N63R Map Thermostat Faults

This Service Information bulletin replaces SI B12 13 16 **dated July 2016**

G12 (750i sedan)	 With the N63R engine
------------------	--

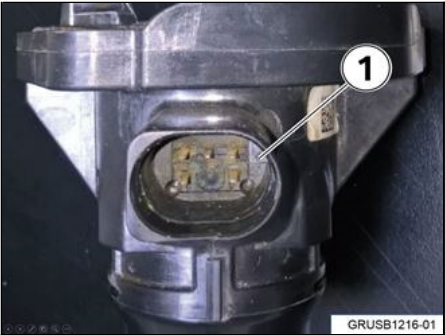
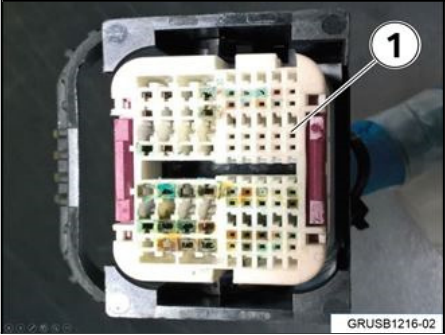
<p>GRUSB1216-01</p>	<ol style="list-style-type: none"> 1. Remove the connector for the map thermostat (1) and check for coolant. <p>Is coolant present in the engine wiring sensor harness for cylinders 1-4?</p> <p>YES - replace the map sensor thermostat (PN 11 53 8 602 282) and the sensor harness (PN 12 51 8 654 414). Go to step 2.</p> <p>NO - continue diagnosis by performing the associated test plan in ISTA/D.</p>
 <p>GRUSB1216-02</p>	<ol style="list-style-type: none"> 2. Check the wiring harness connector at the DME for coolant (1). <p>Is there any coolant at the DME harness connector?</p> <p>YES – Continue to step 3.</p> <p>NO – Repair is complete.</p>
 <p>GRUSB1216-03</p>	<ol style="list-style-type: none"> 3. Check the DME and PDM connector sockets for coolant contamination (1). <p>Is there any contamination at the electrical connectors for the DME or PDM?</p> <p>YES- Submit a TC case to the TC DME group for DME and PDM parts replacement approval</p> <p>NO- Repair is complete.</p>
